Technical Service Bulletin

39 Transfer case leaks

39 19 24 2016880/7 August 29, 2019. Supersedes Technical Service Bulletin Group 39 number 10-05 dated August 3, 2010 for reasons listed below.

Model(s)	Year	VIN Range	Vehicle-Specific Equipment
Q7	2007	000001 – 055095	Not Applicable
	2008	000001 – 011586	Not Applicable

Figure 1. The input shaft seal (A), and the front driveshaft output flange seal (B).

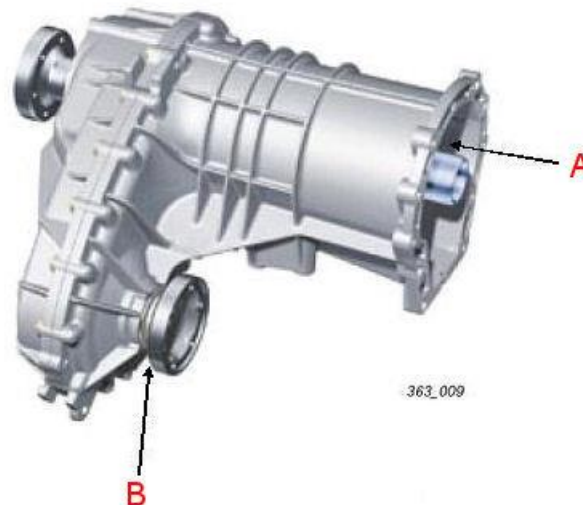
- Oil leak between automatic transmission and transfer case (Figure 1, A).
- Oil leak at front driveshaft output flange on transfer case (Figure 1, B).

- Transfer case input shaft seal is damaged during installation.
- The internal circlip of the output flange shaft has come loose, allowing the output flange to move out slightly, causing seal to leak.

1. Replace the transfer case input shaft seal (Figure 1, A). Refer to Elsa for seal installation instructions.
2. Replace the complete transfer case assembly if the front driveshaft output flange seal is leaking (Figure 1, B). Refer to Elsa for transfer case removal and installation instructions.
